Report
Prepared for
Maddocks Lawyers on behalf of
Lovely Banks Development Group

**Amendment C395 to the Greater
Geelong Planning Scheme**

traffic: evidence

Maddocks Lawyers on behalf of
Lovely Banks Development Group
Our reference 16658T-REP01-F01

Appendix A: Elcho Road Horizontal Design

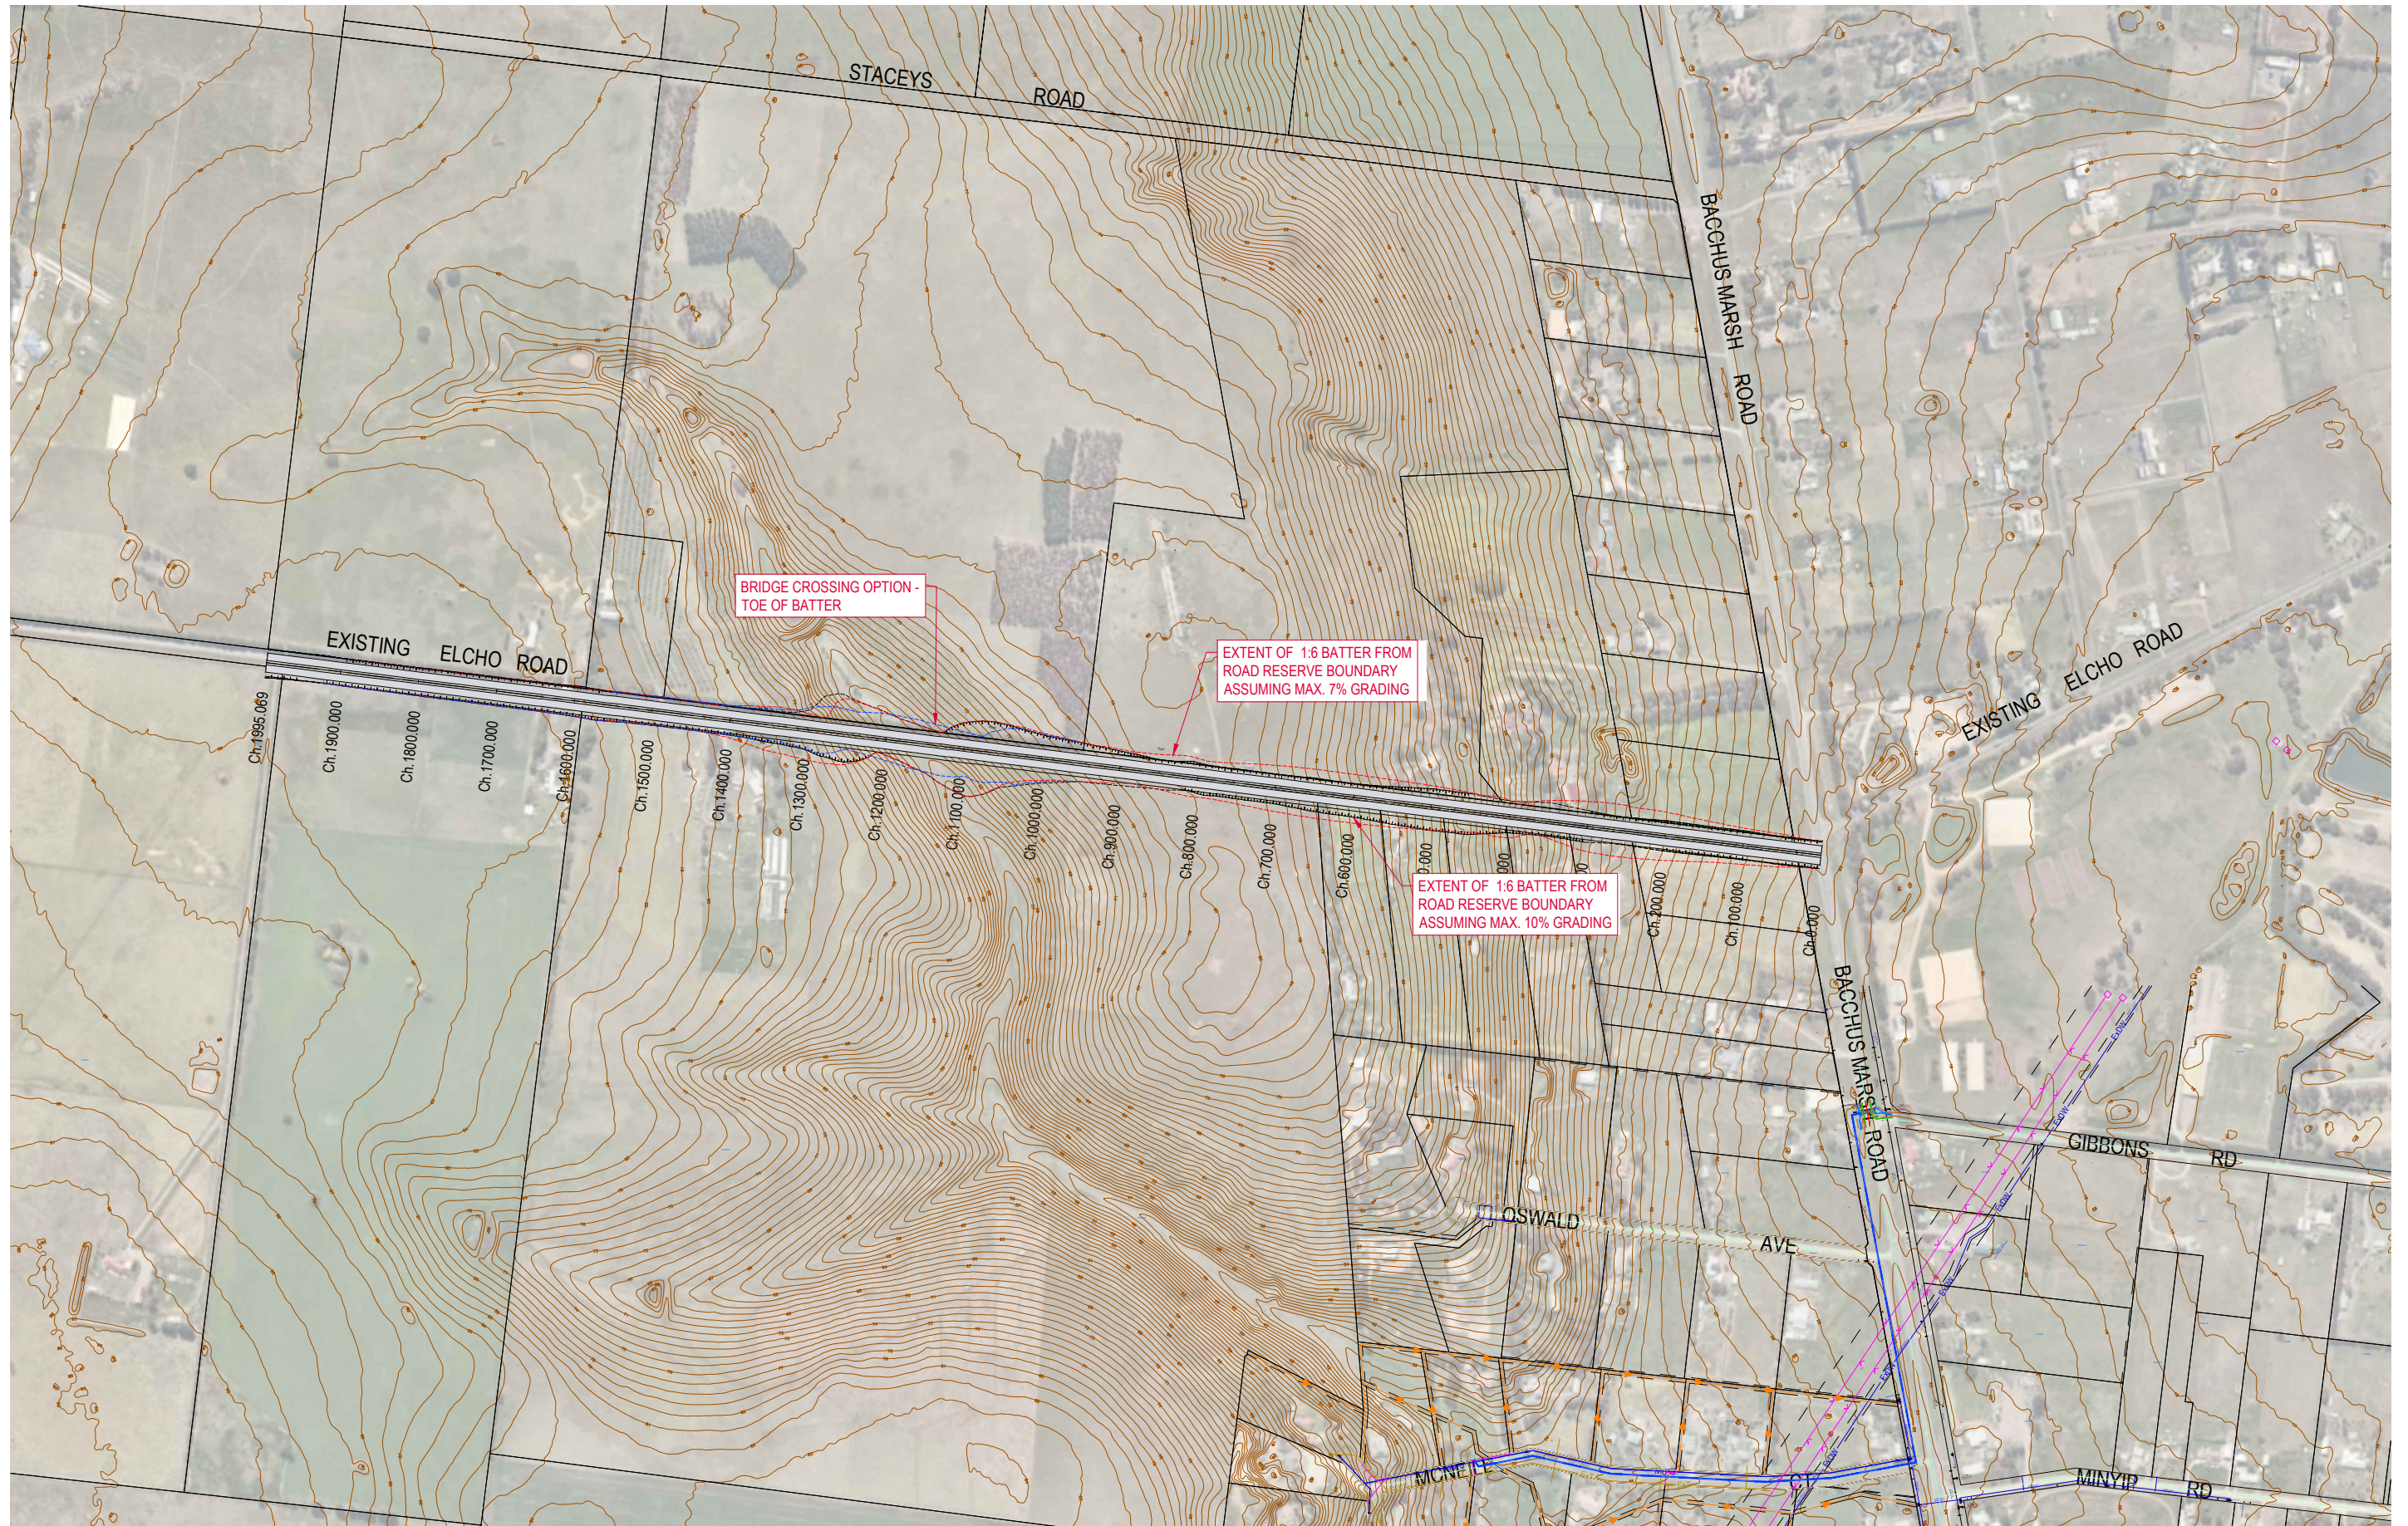
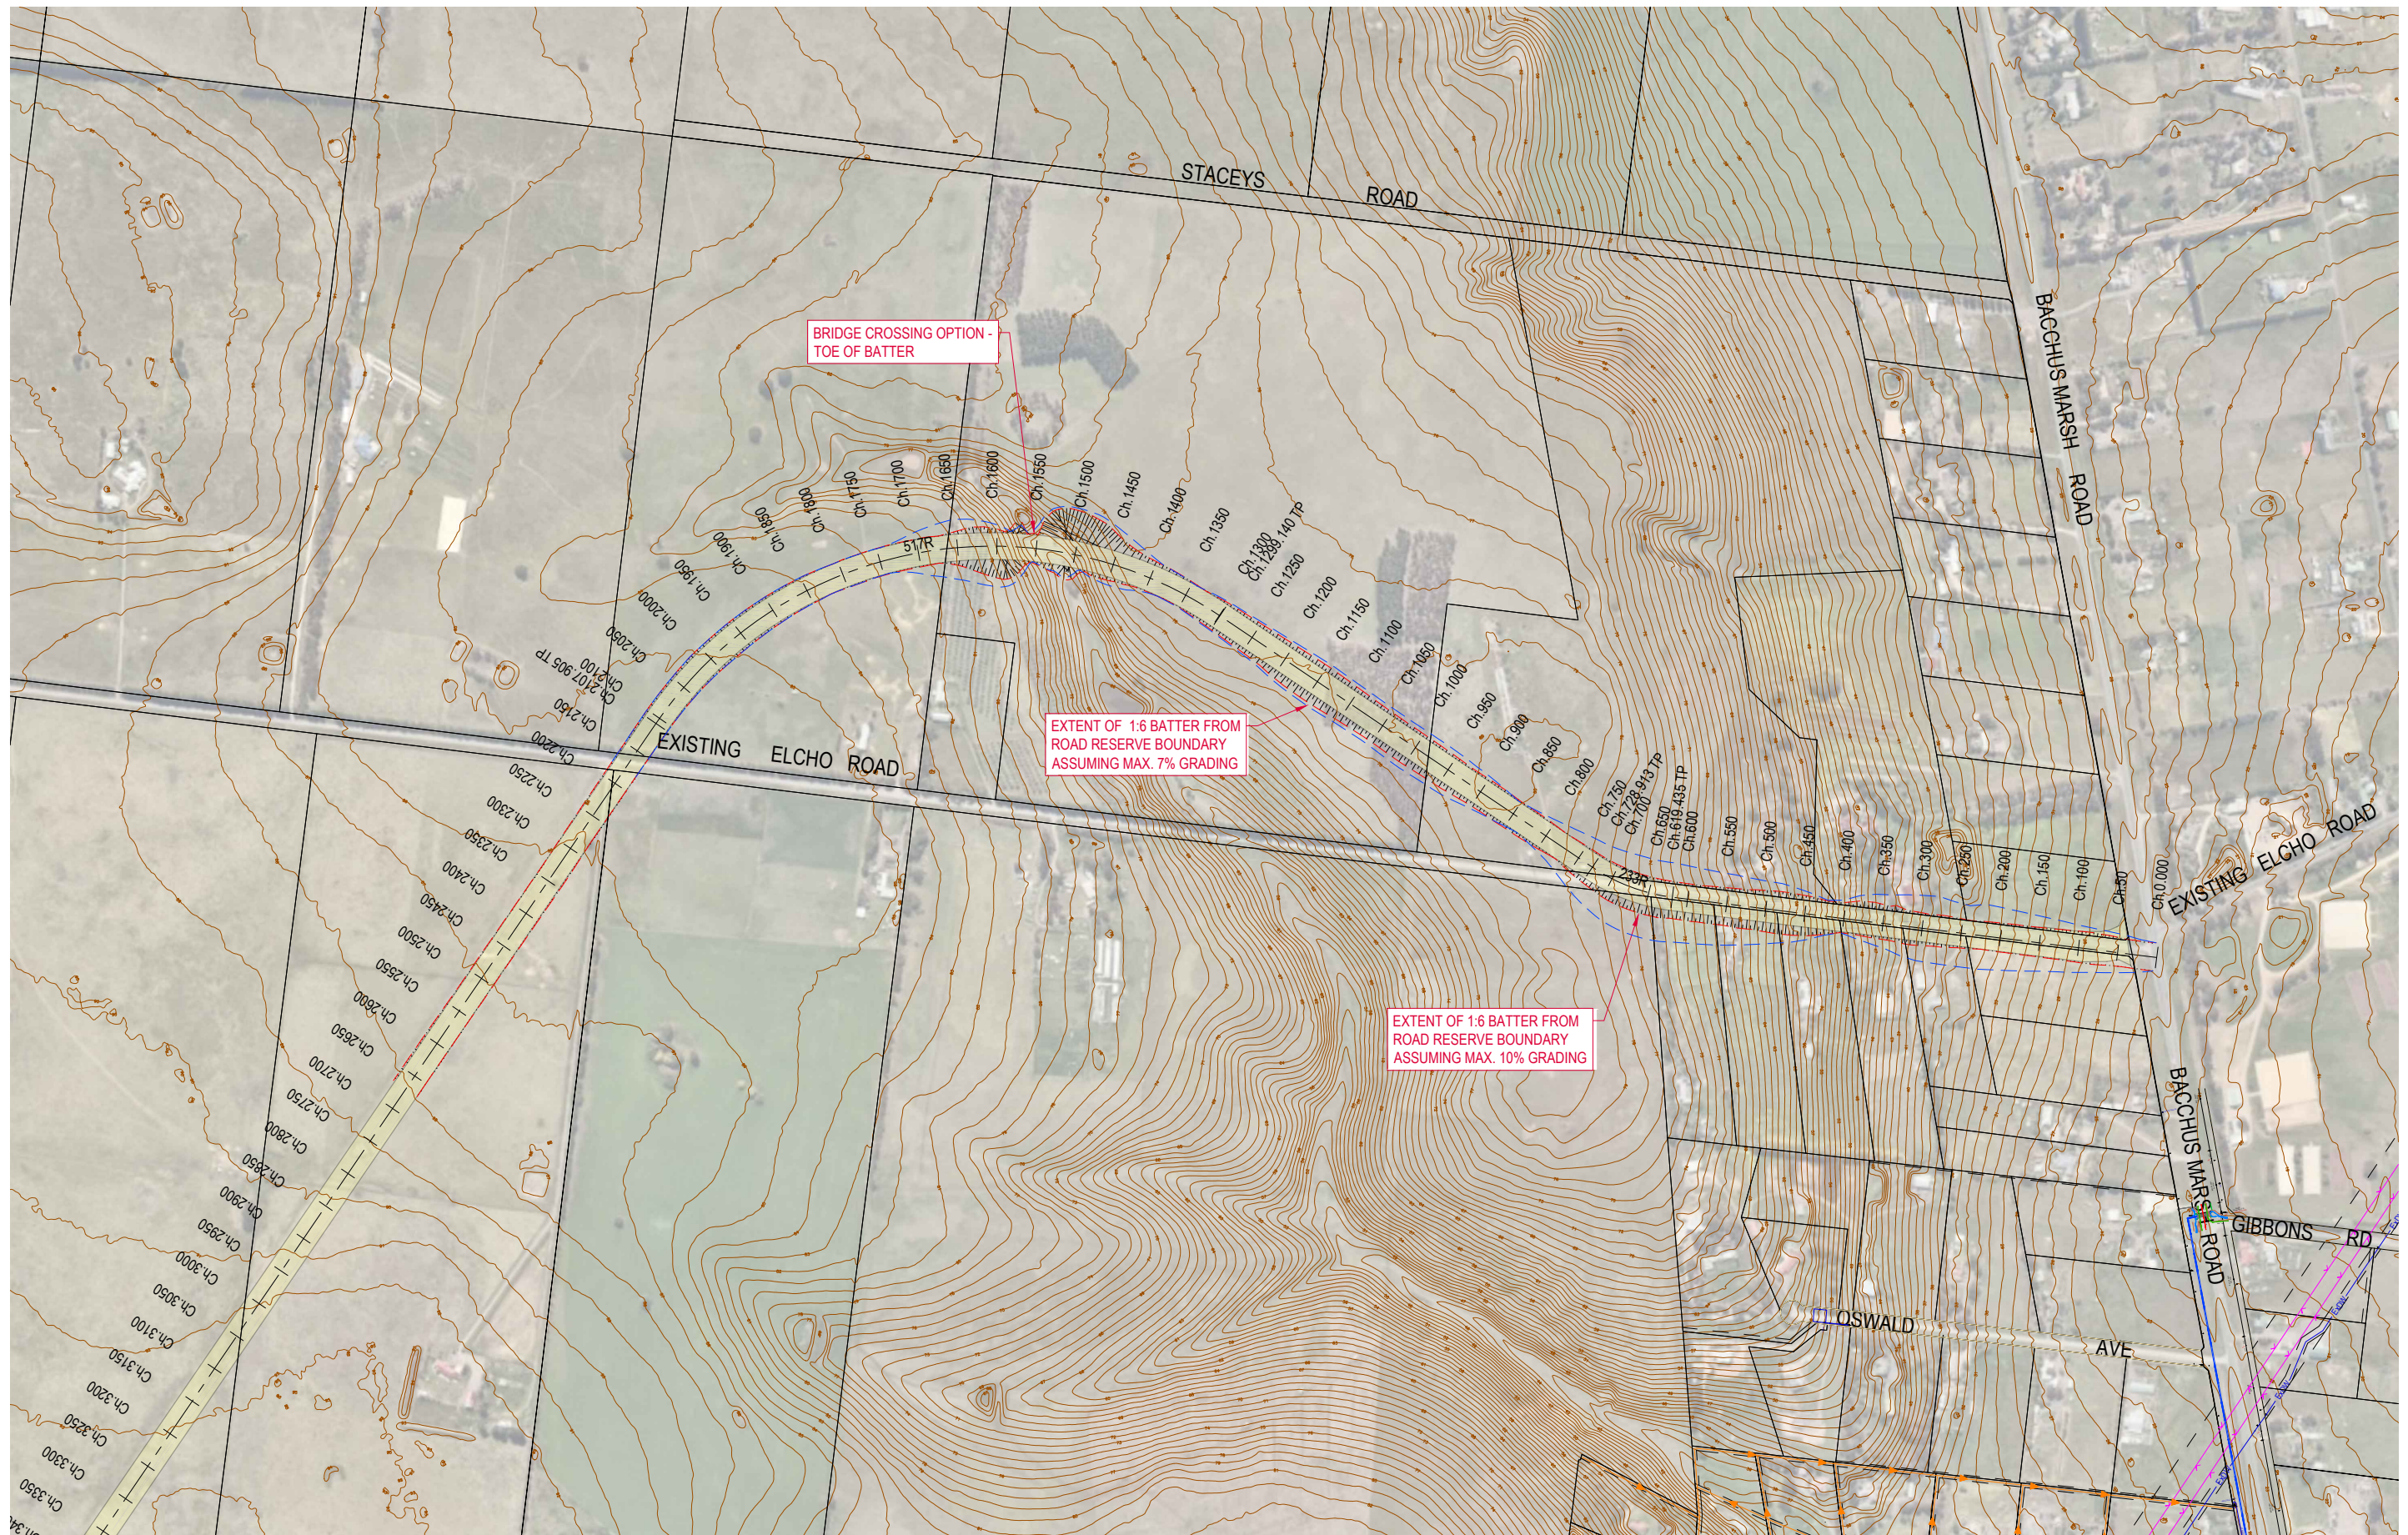
1. I have undertaken a review of the curvature proposed for Elcho Road against the Austroads Guide to Road Design Part 3 – Geometric Design and VicRoads supplements. The tighter of the two curves proposed on the realigned section of Elcho Road has a radius of 233m (refer to Appendix A for Horizontal Geometry plans). Assuming an operating speed of 80km/hr, the superelevation, or amount of banking/camber required for this curve would be less than the 5% maximum specified for an urban arterial road. On this basis I am satisfied that the horizontal road alignment as proposed by the LBDG submission could be delivered within the relevant design parameters of curvature and superelevation.
